Addendum #2

VA Project No.: 553-21-100

Project: Renovate A2 South for Cancer Clinic
John D. Dingell VA Medical Center
Detroit, Michigan

Date: May 1, 2026

Drawing Title
EQUIPMENT PLAN - SECOND LEVEL - ZONE 1A
Approved:

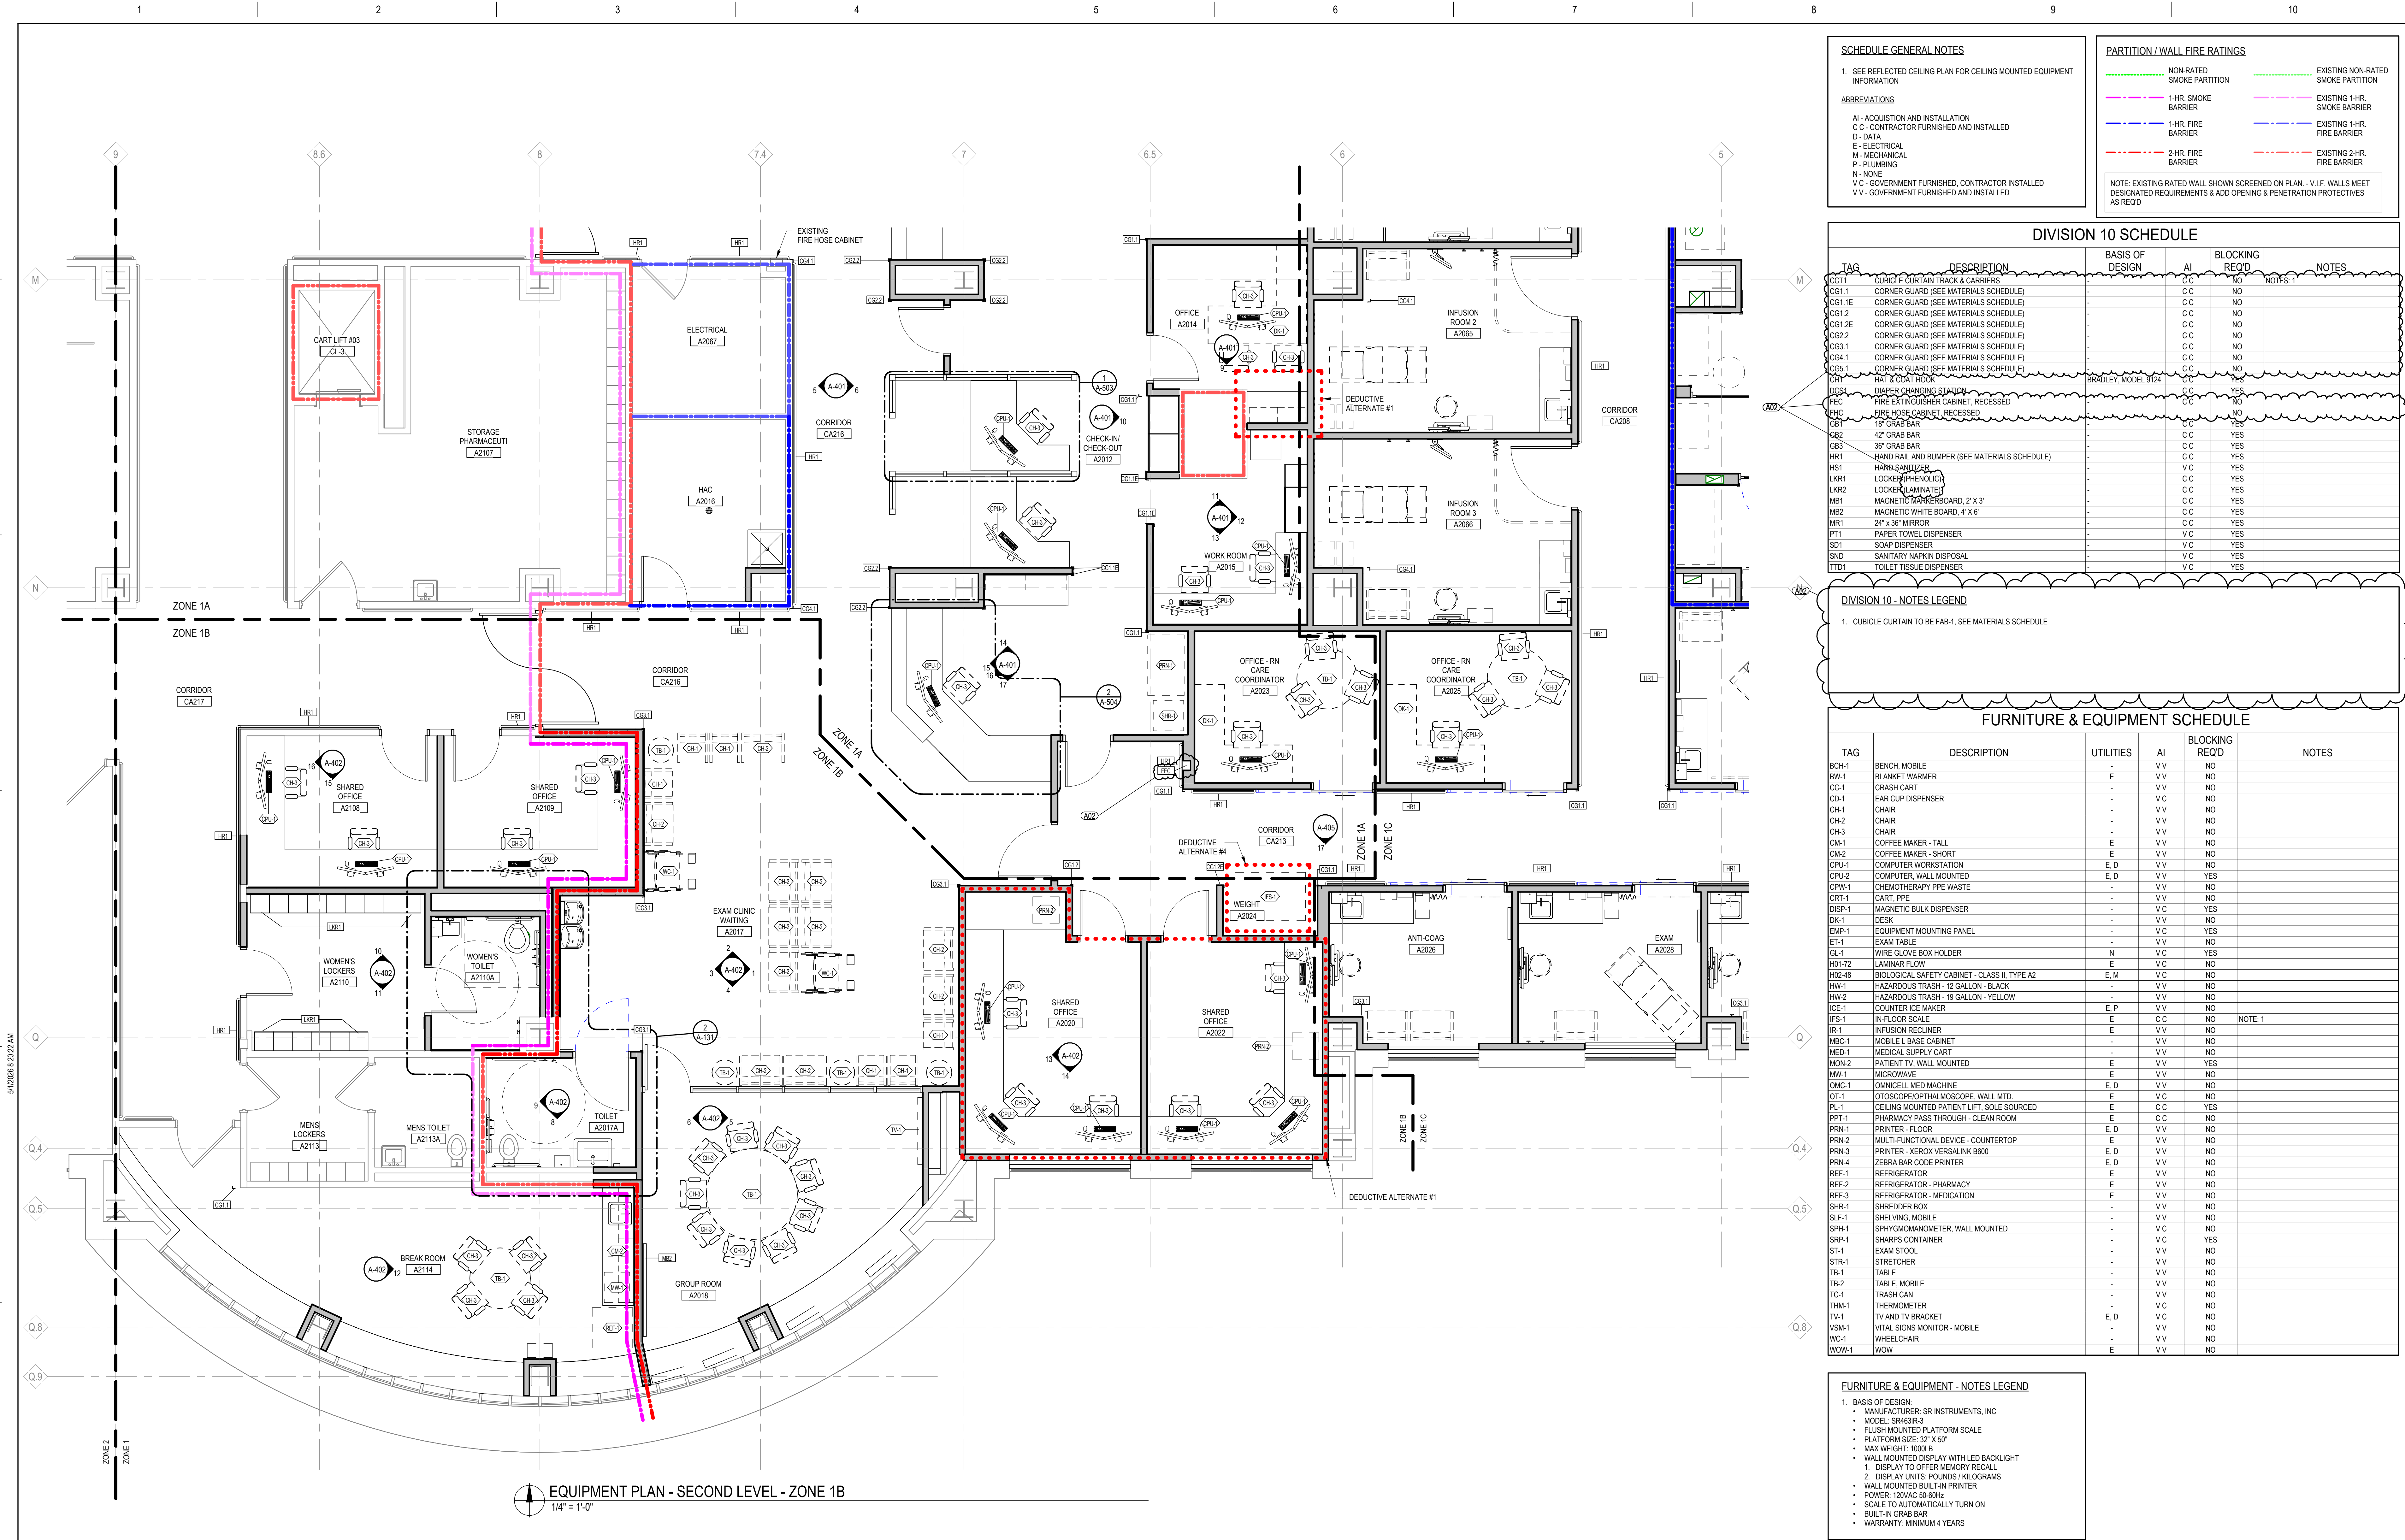
- A2.3 Refer to Sheet G-001 (reissued):
Revise Sheet list to add new sheet I-121.
- A2.4 Refer to Sheets A-122.1A, A-122.1B, A-122.1C, A-122.1D, and A-132 (reissued):
- Revise Division 10 Schedule.
 - Revise Division 10 – Notes Legend.
 - Revise all tags identifying corner guards to match schedule.
- A2.5 Refer to Sheet A-131 (reissued):
Revise detail references.
- A2.6 Refer to Sheets A-401, A-402, A-403, A-404, and A-405 (reissued):
- Revise all corner guards in multiple elevations.
 - Add missing corner guard tags.
 - Revise wall protection heights on multiple elevations.
 - Add signage on elevations as shown.

Project Number
553-21-100
Building Number
Drawing Number
A-405

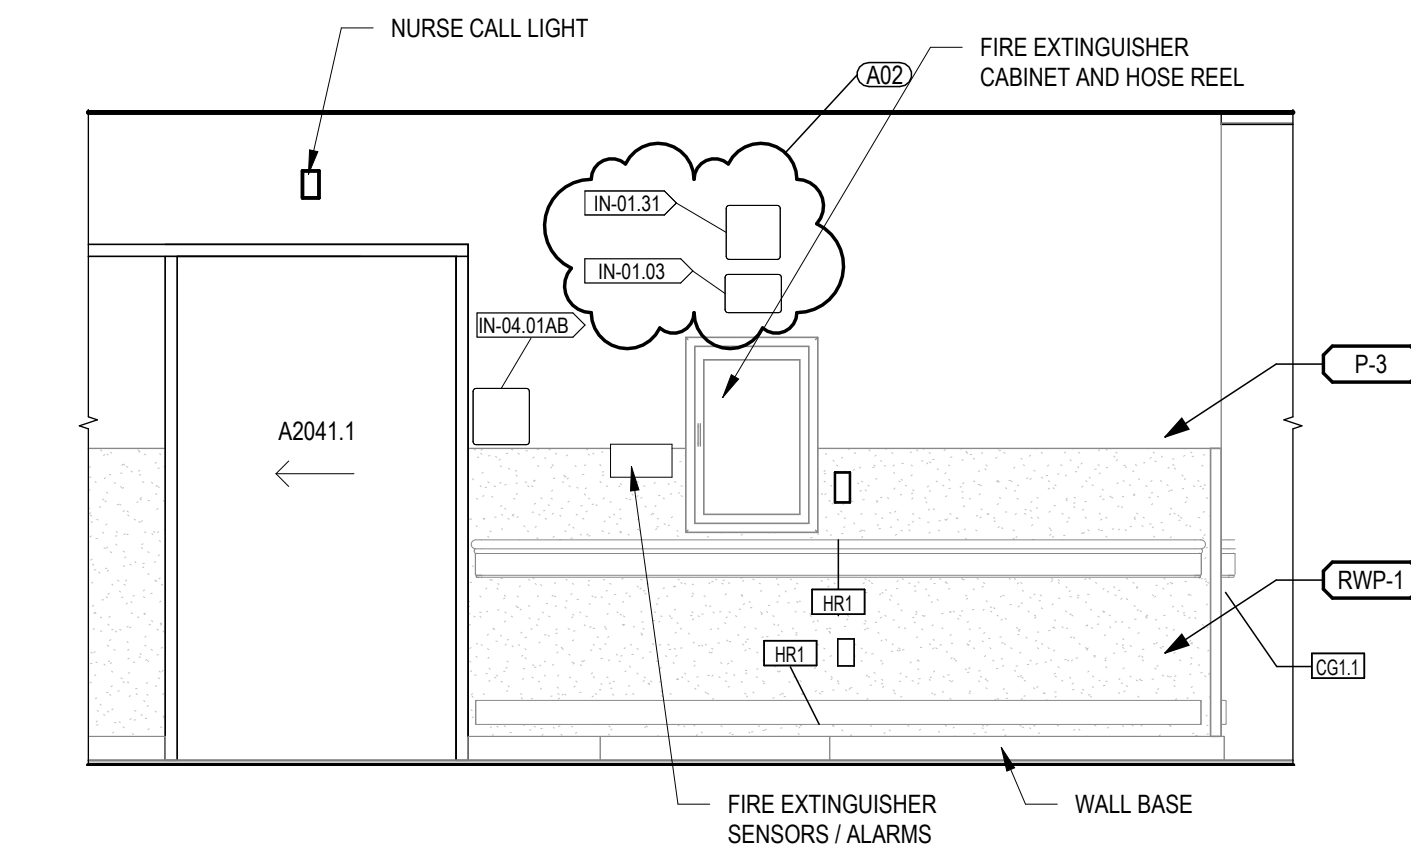
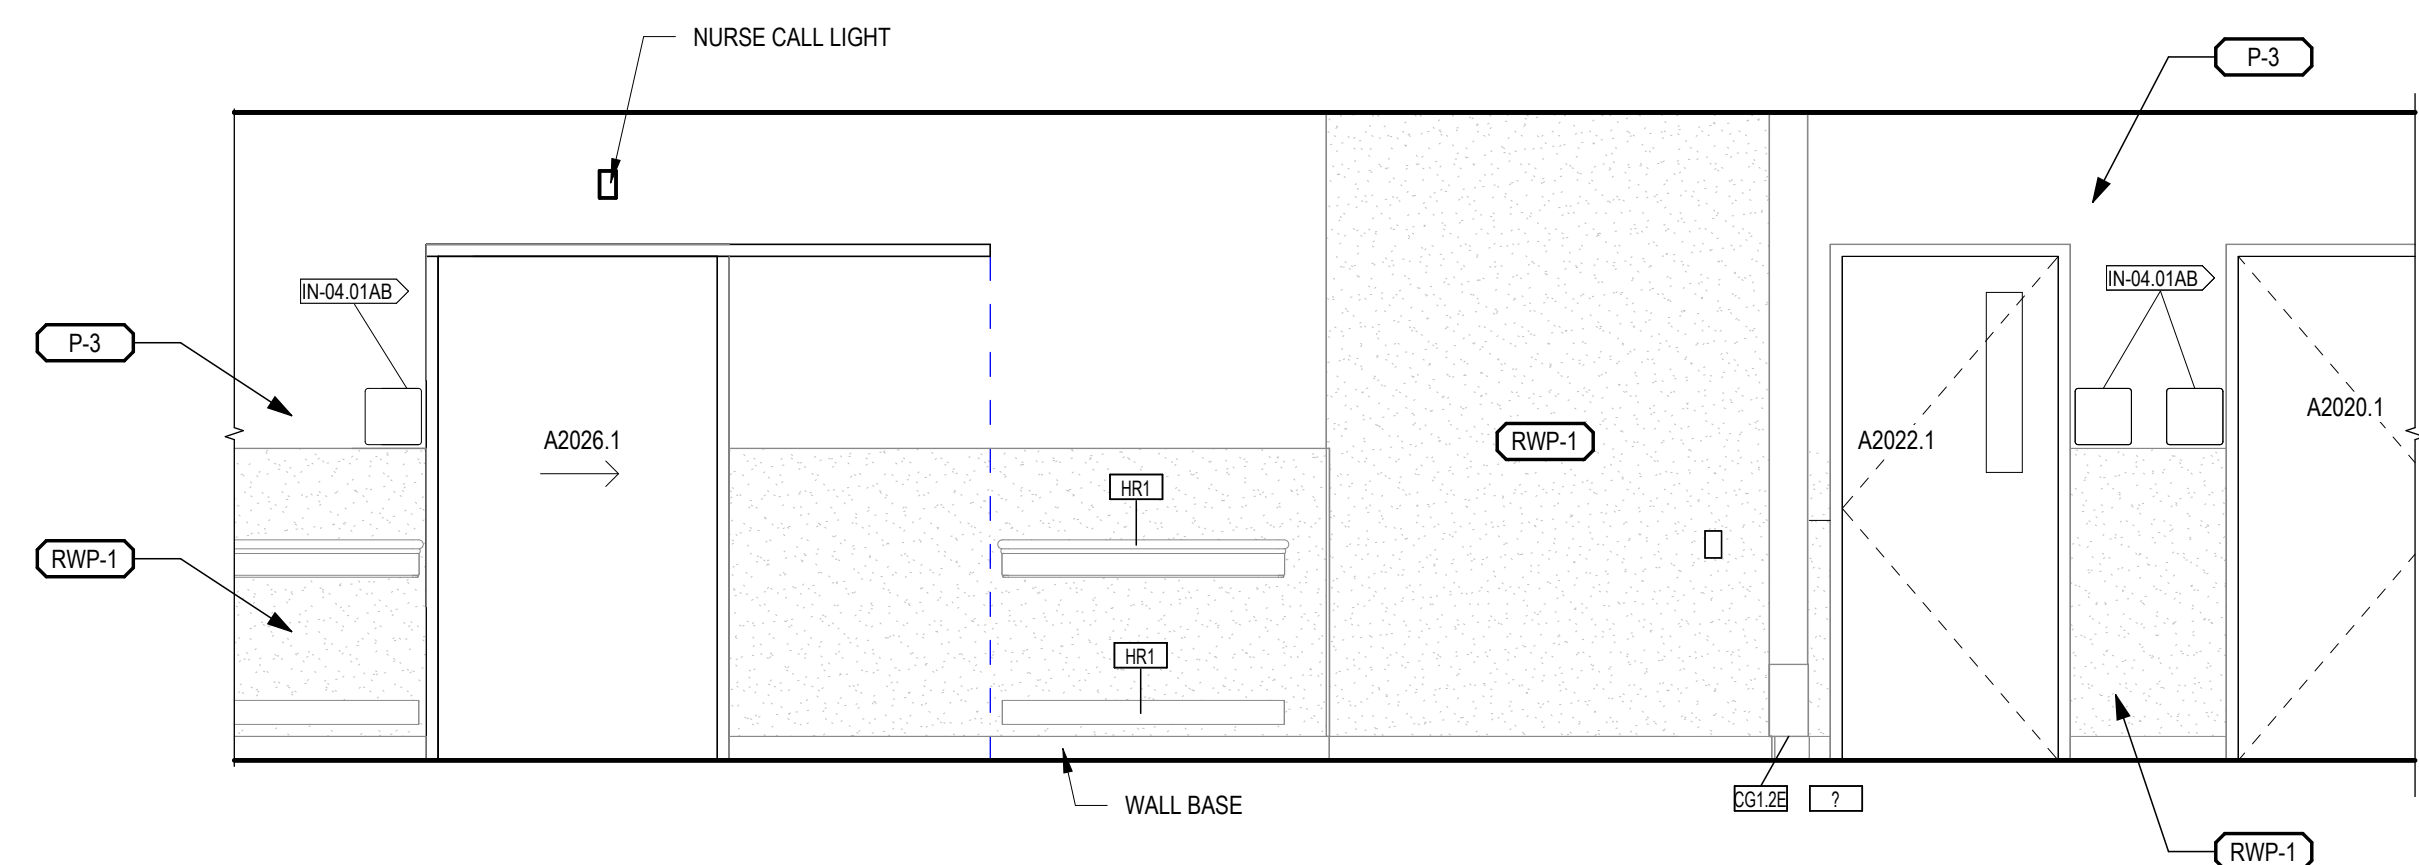
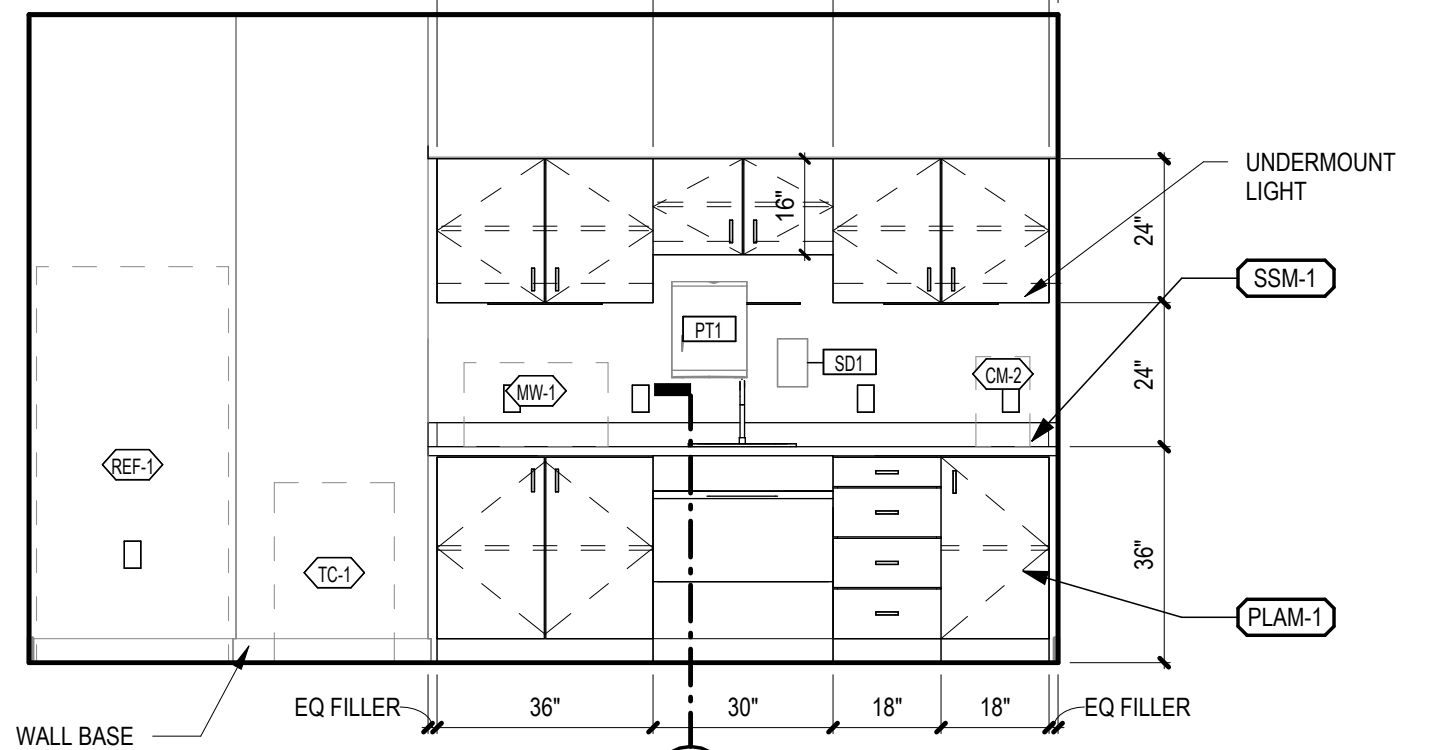
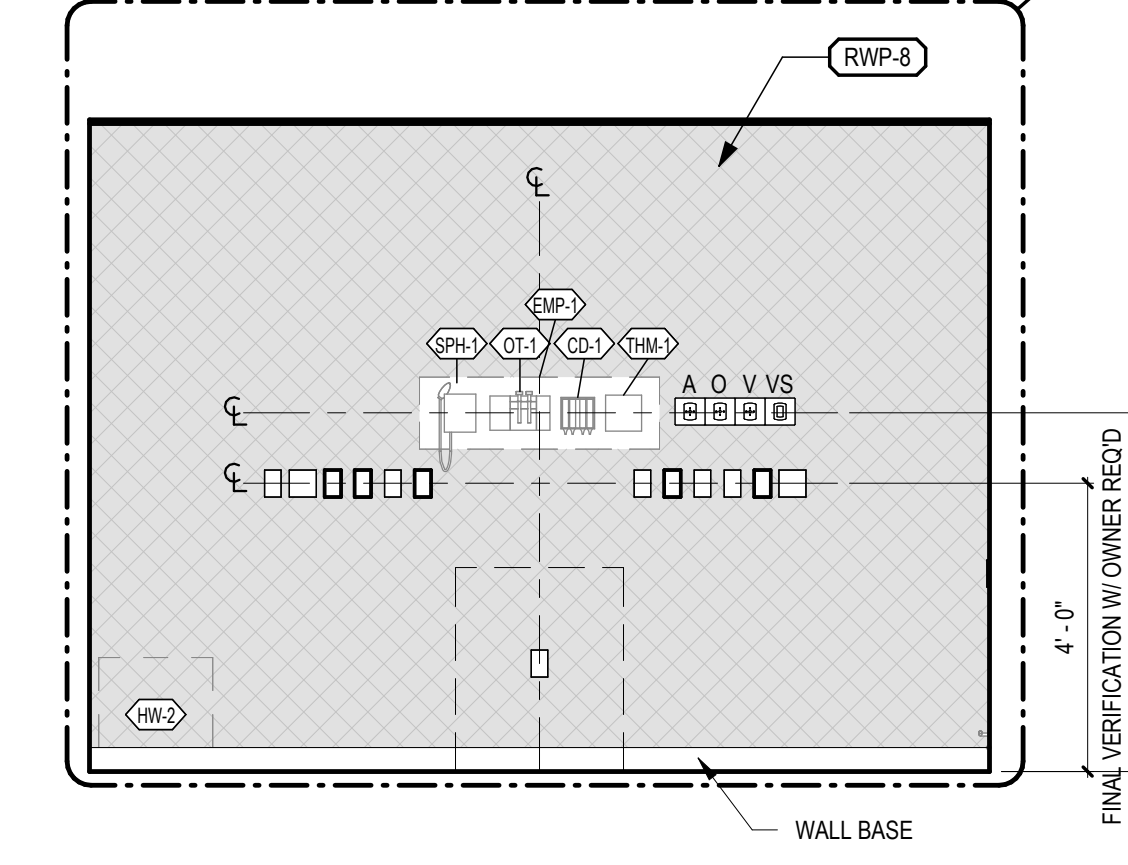
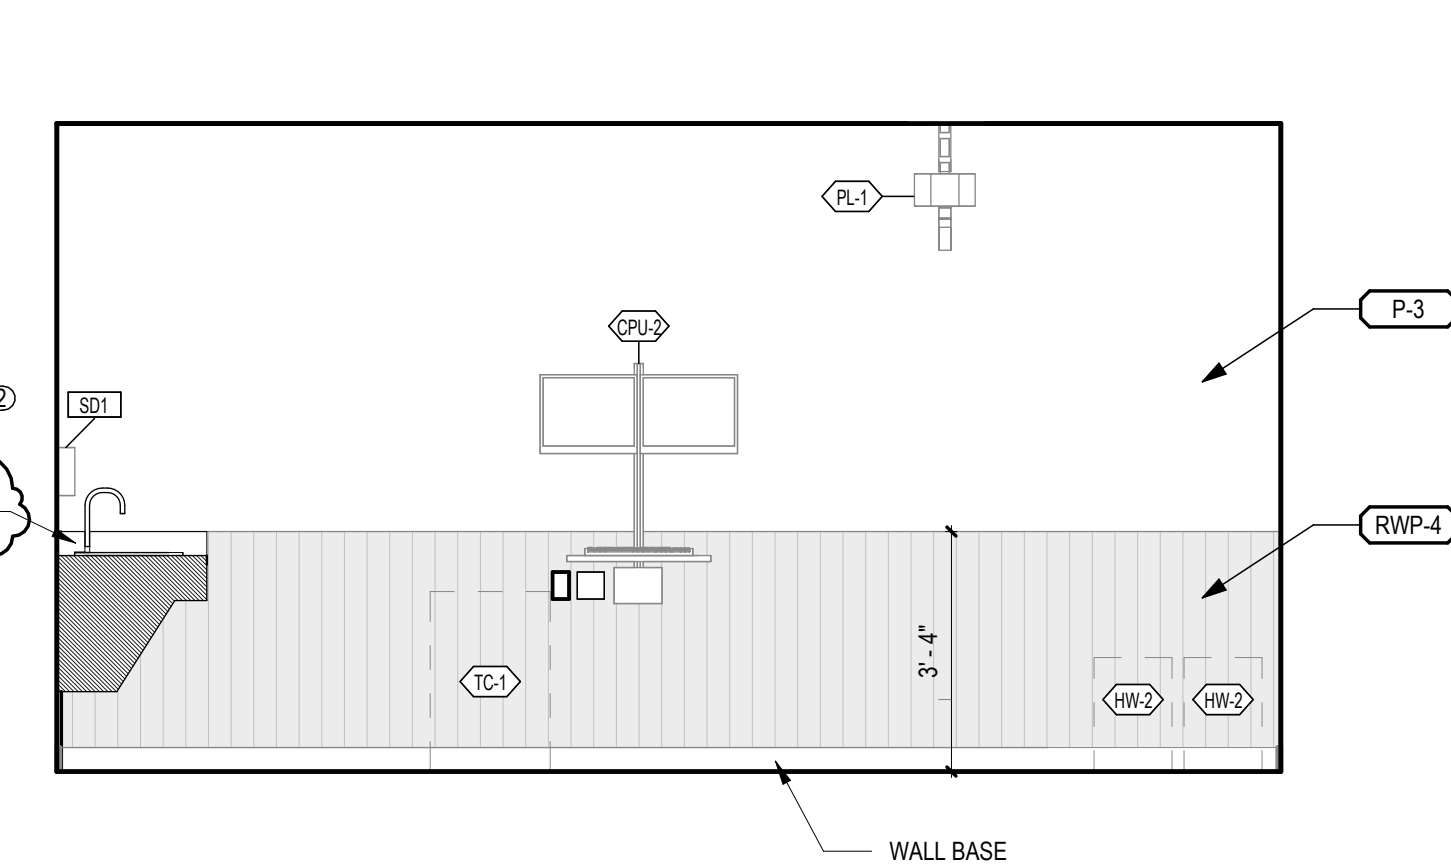
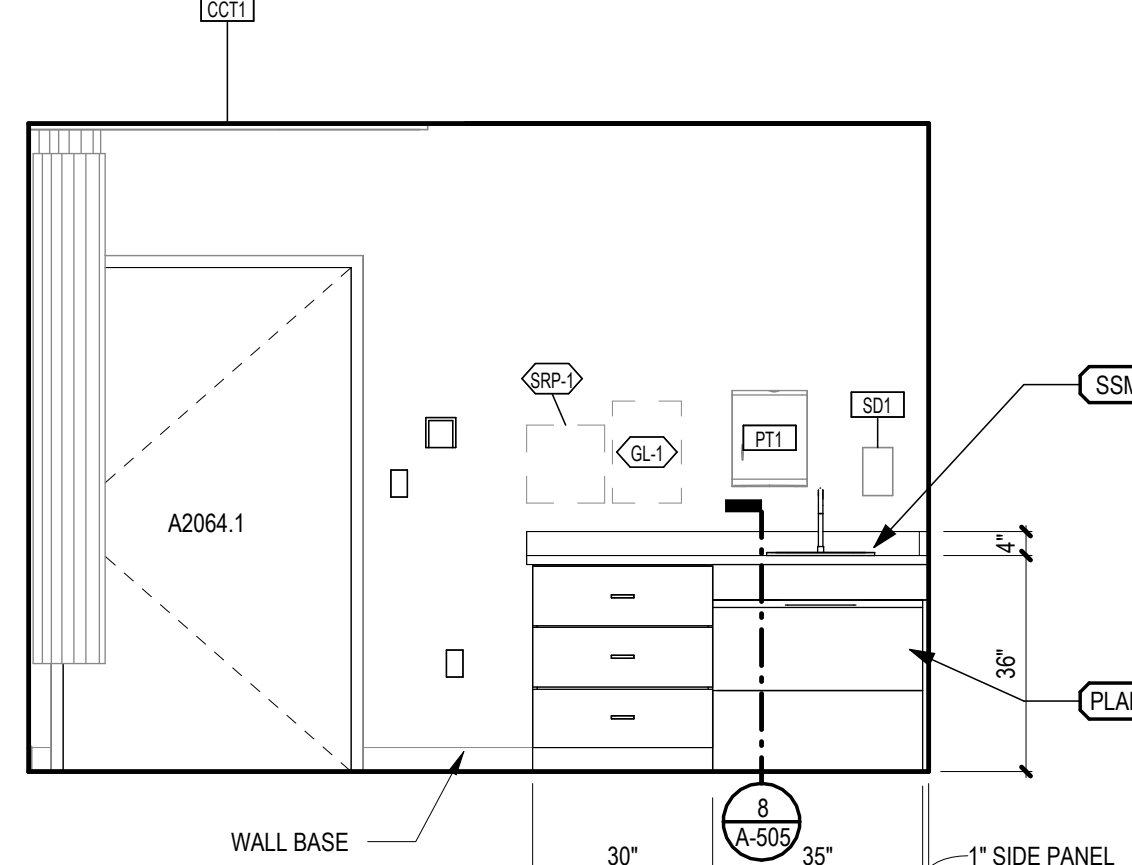
- A2.7 Refer to Sheet A-403 (reissued):
Revise infusion bay casework.
- A2.8 Refer to Sheet A-405 (reissued):
Add side splash to countertops.
- A2.9 Refer to Sheet A-506 (reissued):
Revise detail as shown.
